CPSES-200700229  
Log # TXX-07027

**SUBJECT:** COMANCHE PEAK STEAM ELECTRIC STATION (CPSES)  
DOCKET NO. 50-446  
RESPONSE TO REQUEST FOR ADDITIONAL INFORMATION,  
RELIEF REQUEST B-6 FOR THE UNIT 1 INSERVICE INSPECTION  
(ISI) PROGRAM PLAN FROM THE 1998 EDITION OF ASME  
CODE, SECTION XI, THROUGH 2000 ADDENDA (INTERVAL  
START DATE - AUGUST 13, 2000, SECOND INTERVAL)  
TAC NUMBER MD3315

RESPONSE TO REQUEST FOR ADDITIONAL INFORMATION,  
RELIEF REQUEST B-6 FOR THE UNIT 1 INSERVICE INSPECTION FOR  
APPLYING FULL STRUCTURAL WELD OVERLAY TO PRESSURIZER  
DISSIMILAR METAL BUTT WELDS CONSTRUCTED OF ALLOY 82/182  
WELD MATERIAL, TAC NUMBER MD3315, DOCKET No. 50-445

Weld Repair Decision Process  
Rev 1

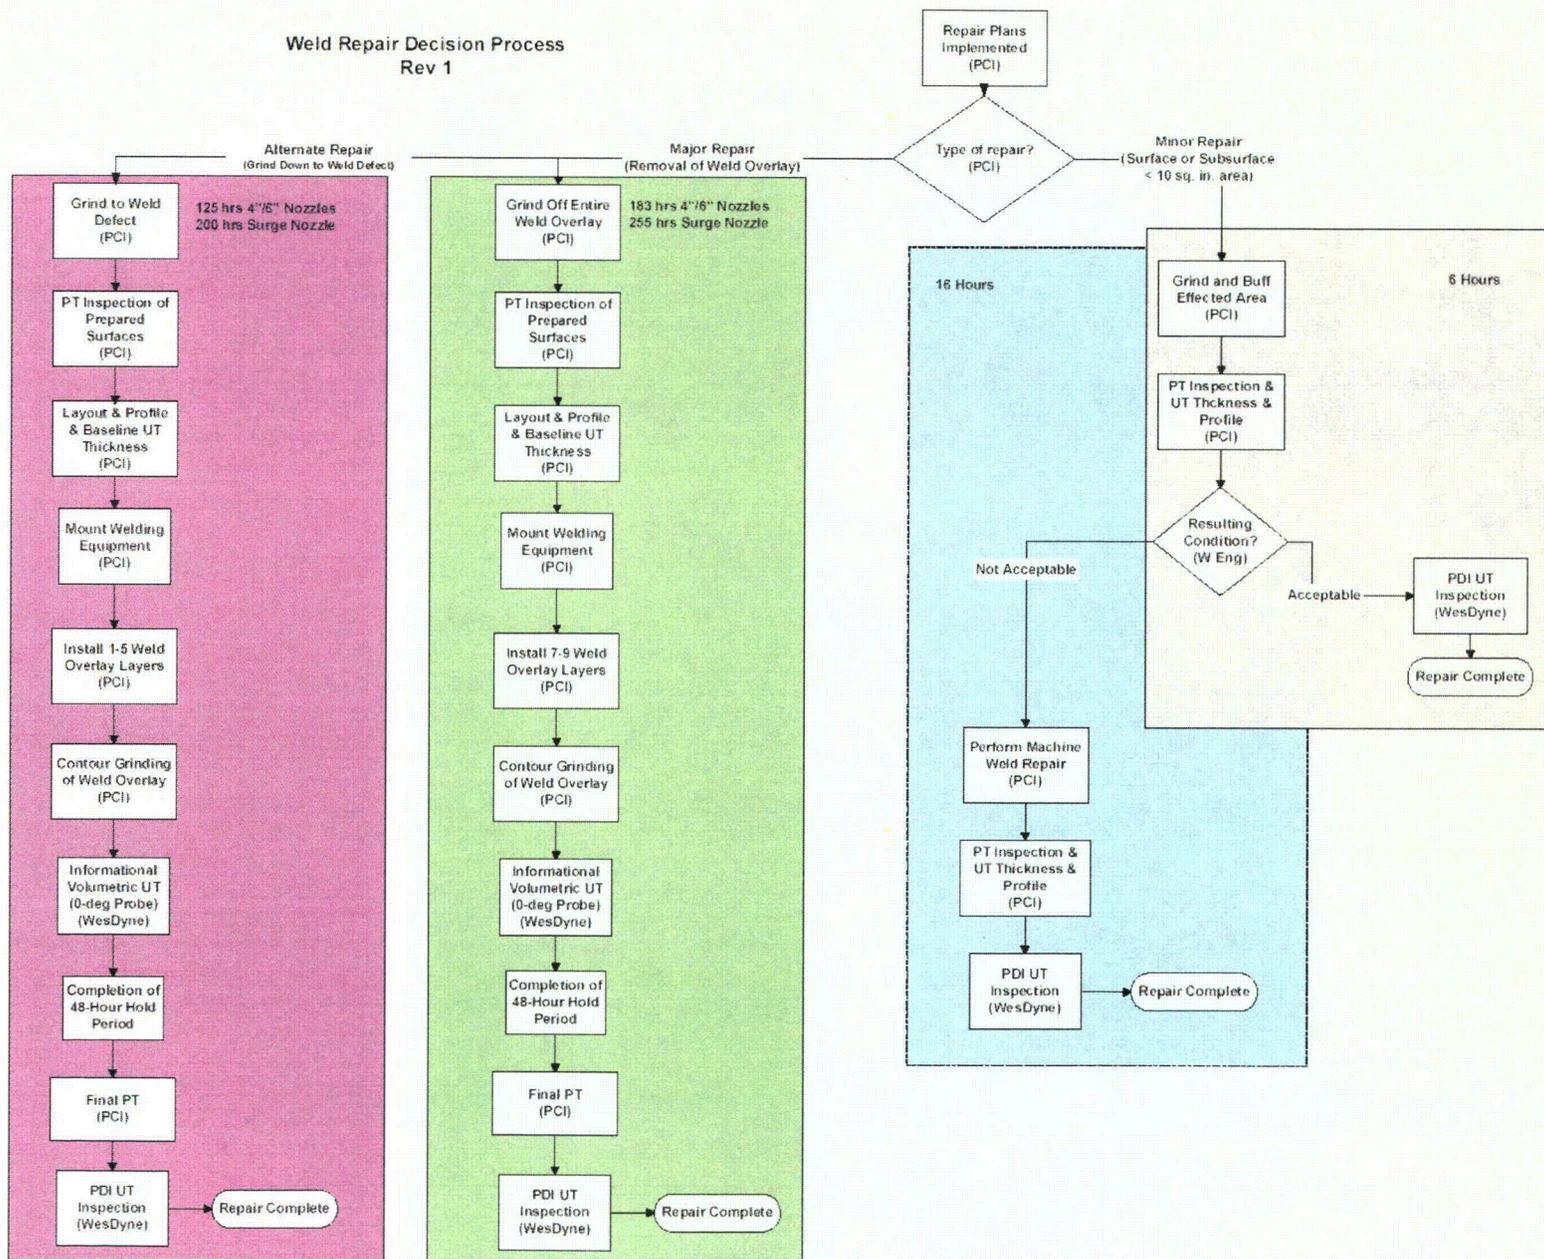
Please discuss your repair strategy if the post overlay preservice inspection results identify indications that exceed the acceptance criteria under Table IWB-3514-2.

**TXU Response**

Repair strategy is detailed in a Westinghouse Weld Repair Decision Process (Decision Tree Flowchart shown on the following page) which defines the decision logic for minor, major and alternate repair scenarios.
